Response to Reviewer 1 comments

This paper examines the ocean radiant heating parameterization and its impact on prognostic schemes simulating the diurnal cycle of SST. Typically, in such prognostic schemes (e.g., Zeng & Beljaars (2005)) the diurnal warm layer depth is fixed at 3m. This assumes negligible diurnal warming and minimal radiative heating below this depth; however, this paper notes that this is not necessarily the case and suggests that the warm layer depth in the prognostic scheme should instead vary spatially and temporally depending on the e-folding depth derived using chlorophyll data. This seems to me to be a worthy improvement and an interesting study.

Response to Reviewer 2 comments

- We added the sketch in the introduction section (see Figure 1), with the caption “Figure 1. Sketch of the cool skin and warm layer adapted from Donlon et al., 2007. Vertical discretization of NEMO levels is shown in green (not perfectly in scale with the underlying y-axis).”

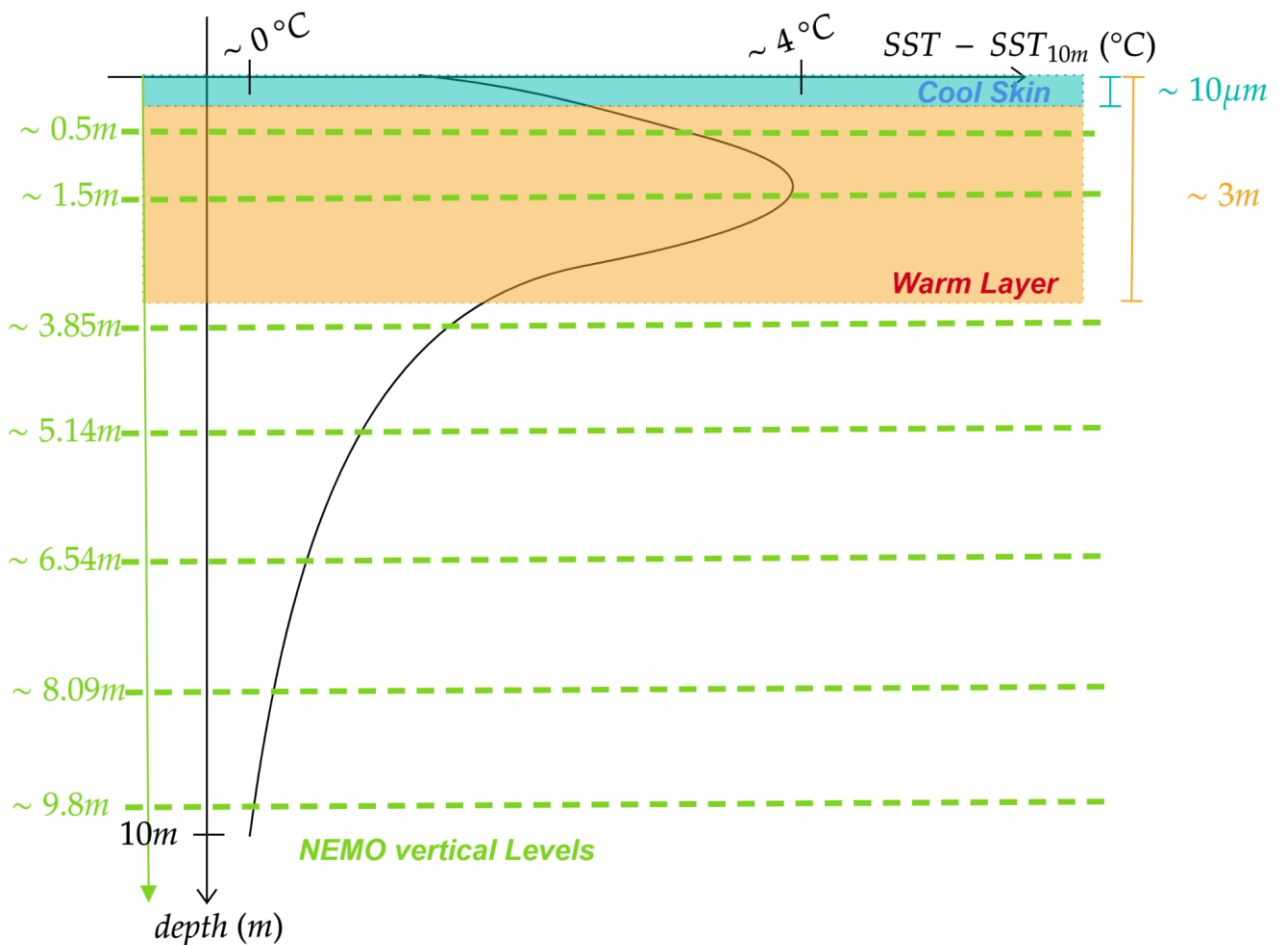
- **Description of the model/new parameterization. It would be useful to add a diagram illustrating the layers, the cold skin layer and the warm layer. In the description of the model (e.g. Eq 5 and 10) it would be useful to understand what the prognostic variables are and how this parameterization is related to the OGCM internal variables. (e.g. Nemo potential temperature). Nemo vertical discretization in the upper layer could be also shown in the diagram.**

We can provide a schematic diagram of the cool skin and the warm layer (see respectively panels a and b of the figure below), even if it is just a re-adaptation of the sketch given in Donlon et al., 2007.

Since the cool skin temperature difference is time-independent, that is the diagnostic part of the scheme, while the warm layer temperature difference is the prognostic variable, since its determination requires temperature difference both at time t and at the preceding time step. By default, the parameterization is conceived to simply diagnose the skin SST within a simulation, without actually entering in the dynamics. For each of the simulations, we substituted SST in the first model level with the skin SST calculated from each scheme in the coupled ocean-atmosphere model. In the diagram below you can also notice that vertical levels within NEMO are not equally spaced (we didn't report them perfectly in scale with the underlying y-axis - the figure is just qualitative).
